Subject: Obstruction of emergency canopy jettison and avoidance of possible injuries

Effectivity: **All LS6 models.**

(TM6036 / 2)

Deflector with edge protector:

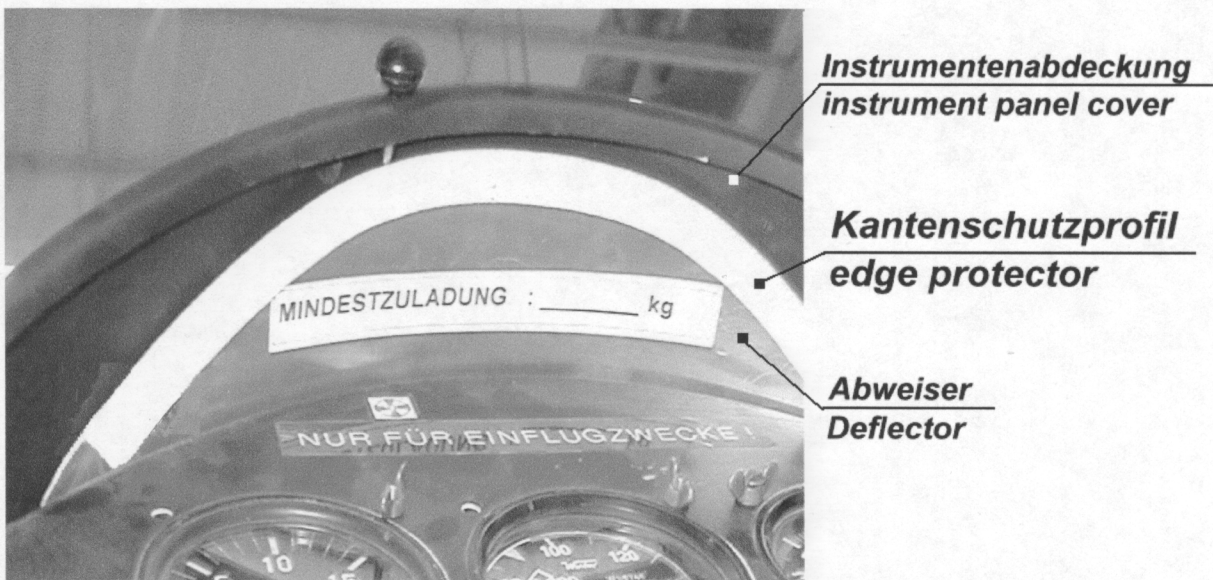
Modification of the Deflector

1. Drill blind rivets. If need be, unscrew upper instruments (Hexagon head 2.5 mm und ratchet with 7mm socket) and place them on top of the second row.
2. Mark new fixing holes 10mm (0.4 in) offset from originals and drill. This enables to use the existing holes at the instrument panel edge.
3. Shorten straight edge of deflector by 10 mm, soften edge and paint black. Maximum depth of deflector after trimming is 100 mm (3.94 in).
4. Rivet deflector back to top of instrument panel, facing towards the pilot (Blind rivets \varnothing 4mm*6.5, large washers \varnothing 4.3 * 12 * 1mm DIN 9021-St).
5. Push edge protector (as long as instrument panel allows) onto deflector edge.

Should the instrument panel cover be too short to allow the protector to fit underneath, contact manufacturer stating model and serial number.
